1. Type of Well	Gas Well 🔲 Oth	er				8. Well Name and N FEDERAL LL 1	0.		
2. Name of Operator COG OPERAT	FING LLC	Contact: E-Mail: bmaiorino	BRIAN M @concho.c	AIORINO		9. API Well No. 30-015-20855			
3a. Address 3b. Phone No				ne No. (include area code) 2-221-0467			10. Field and Pool, or Exploratory YARROW;BONE SPRING,SOUTH

Additional data for EC transaction #217398 that would not fit on the form

Federal LL 1 30-015-20855 COG Operating LLC September 03, 2013 Conditions of Approval

O:\Regulatory\Basin\Recompletions\Federal LL	1\Federal LL	1 proposed wellbore.xlsx

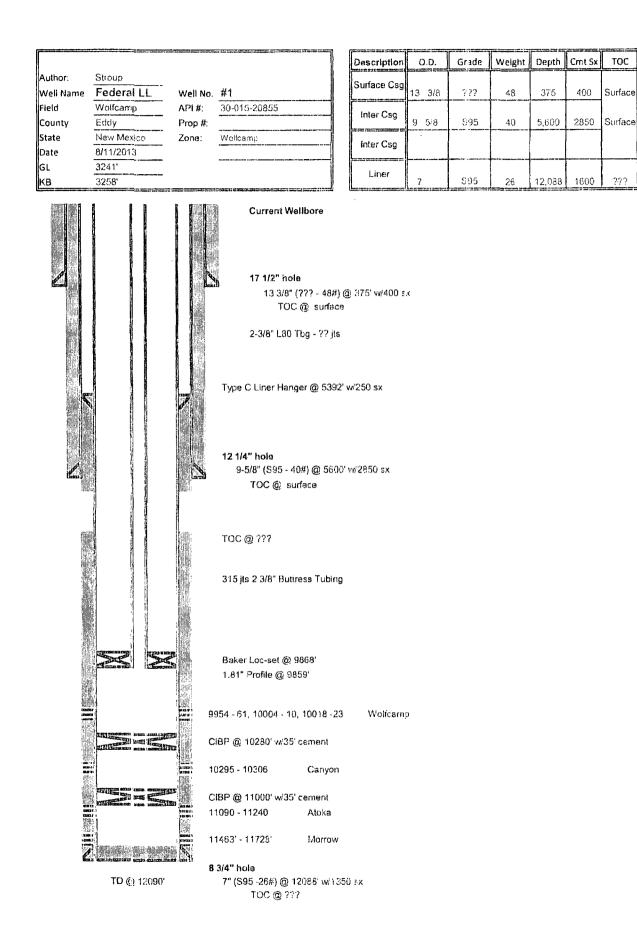
- 1. Operator shall tag existing CIBP at approximately 10,245'.
- 2. Operator shall set CIBP at 9,900 and place 25 sx of Class H cement on top. Tag required.

- 3. Operator shall place a Class H cement plug from 8,800'-8,600' to seal the top of the Wolfcamp formation.
- 4. Submit a copy of CBL to BLM. If squeeze is needed, submit plan to BLM CFO Engineer for approval.

- 5. Must conduct a casing integrity test before perforating and fracturing. Submit results to BLM. The CIT is to be performed on the production casing to max treating pressure. Notify BLM if test fails.
